ABRAHAM - BEACH PROPERTY
INTERSTATE 25 AND MONTANO

GRADING AND DRAINAGE PLAN

DRAWN BY	BJF
DATE	09/10/15
	2015016_GRB
SHEET #	C1
JOB #	2015016

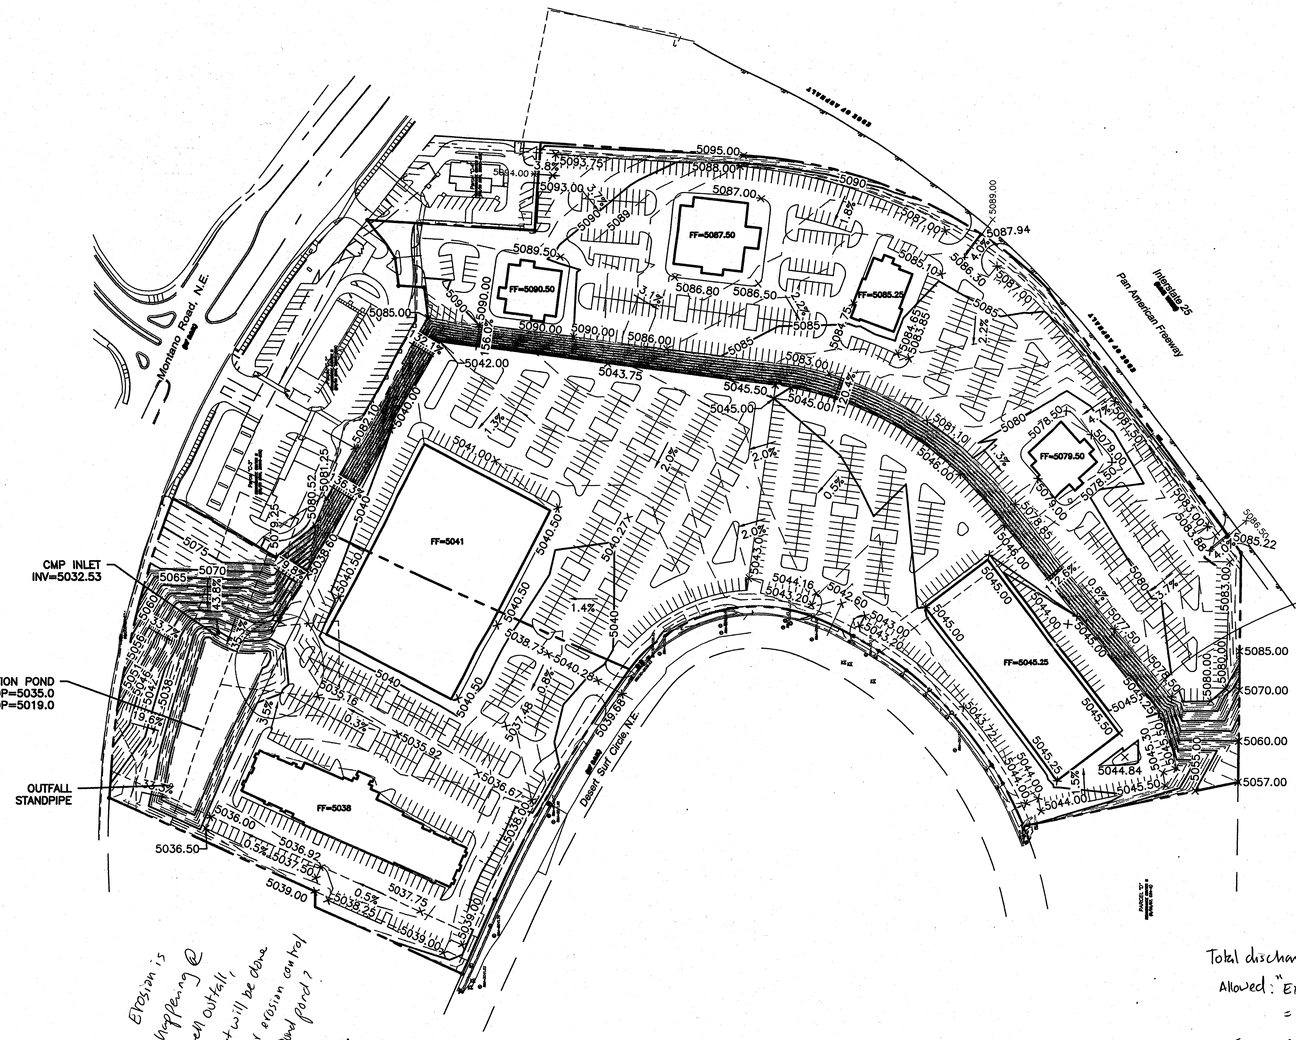
How are these very steep slopes protected? How do flows get from B1 and B5 to B2 and B6?

Erosion is happening @ Shell outfall, What will be done for erosion control around pond?

Total discharge from site:
Allowed: "Existing" + 0.1 cfs/acre
= 37.10 cfs
From report, 2.66 + 28.17 + ~~First flush~~ = 30.83 cfs ✓

Show basins on G+D plans
